Technical Service Bulletin

Over-center Springs and Soft Clutch Pedals

Example Diagram of an Over Center Spring Location

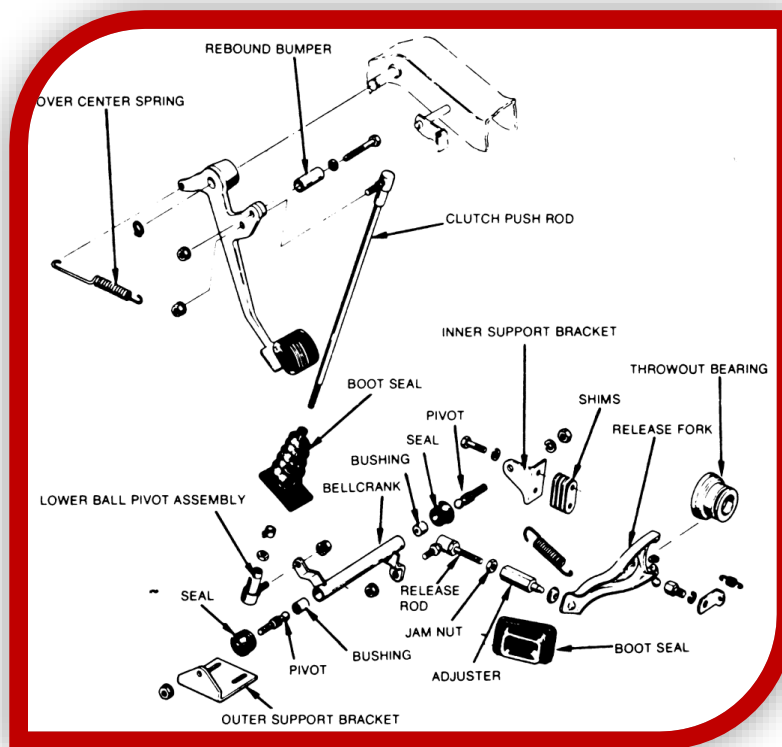
"Over-center" or release assist springs as they are sometimes called, may result in a very soft pedal when a coil spring clutch is replaced with a diaphragm spring clutch. These springs are designed to assist the driver in pushing the pedal down to provide softer clutch pedal engagement.

Designed to reduce the higher pedal effort associated with coil spring clutches, over-center springs may overcompensate when a diaphragm spring is installed.

The results can include a very soft clutch pedal, and in some cases, a clutch pedal which will go to the floor- and stay there.

**To eliminate these problems, remove the over-center springs.*
